BULLETIN #222-B

W60 AND W61

High Speed Range Light Flashes and Erratic Feed Motor Speed

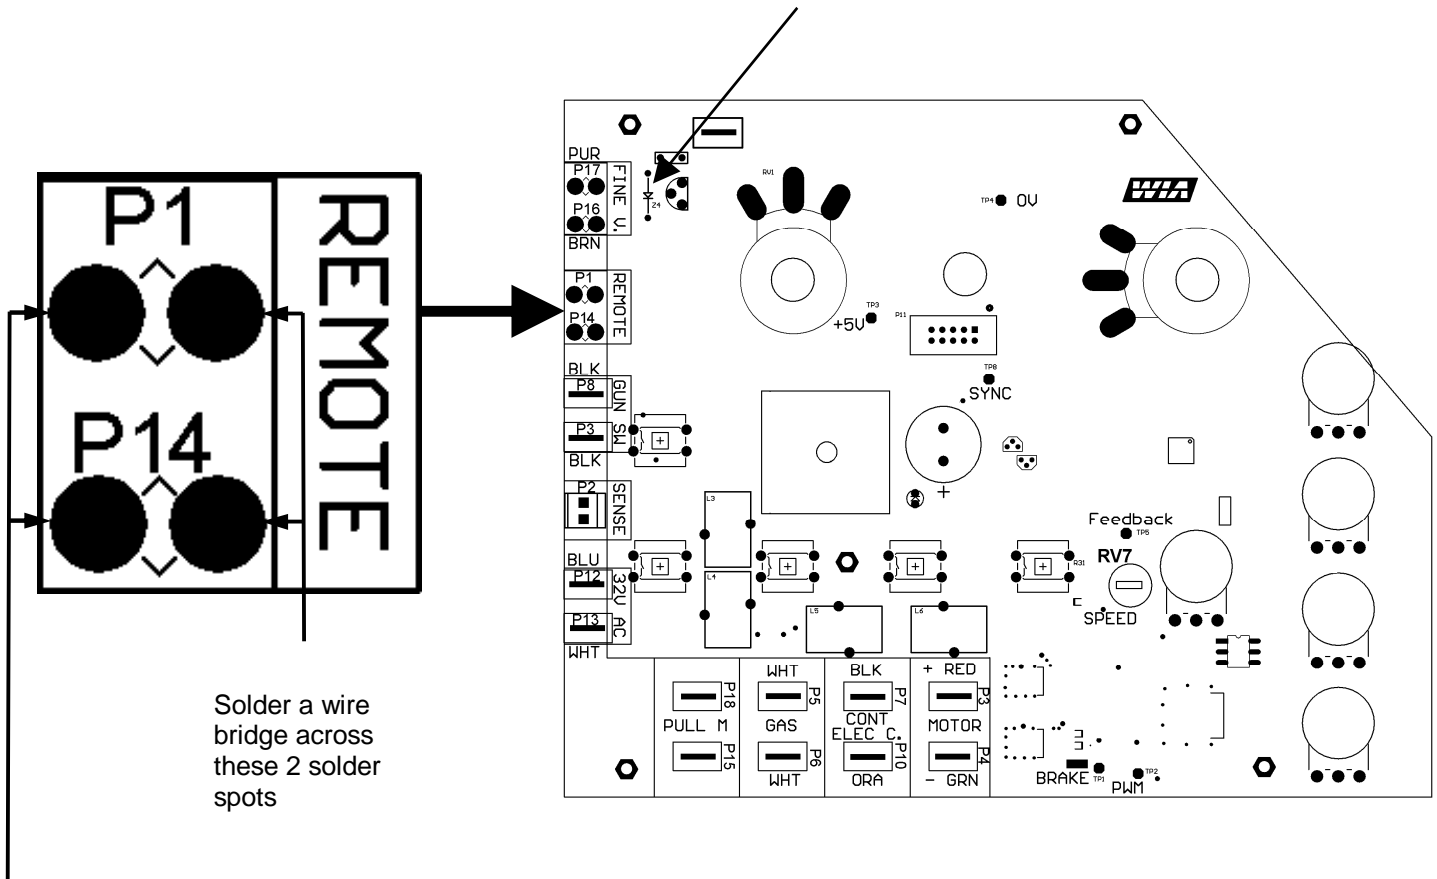
The fault has been tracked to a spare (currently unused) input on the wirefeed pcb. When there is an electrical connection between the case of the wirefeeder and the power source case, some electrical noise can be generated onto this signal line and cause the micro processor to malfunction.

All PWA008 and PWA009 wirefeed pcb's manufactured from now on are modified to prevent this problem and are labelled Issue I (PWA008) and Issue G (PWA009).

An effective field remedy is to tie both inputs down to circuit ground on the pcb by soldering a link between P1 and P14 on PWA008 or PWA009 wirefeed pcb. Note: ensure that the correct solder spots are joined as shown in the enlargement below.

If a link (0 ohm resistor) is present at Z4 location, pcb is already modified.

NOT these 2 solder spots (they are not connected to the circuit)
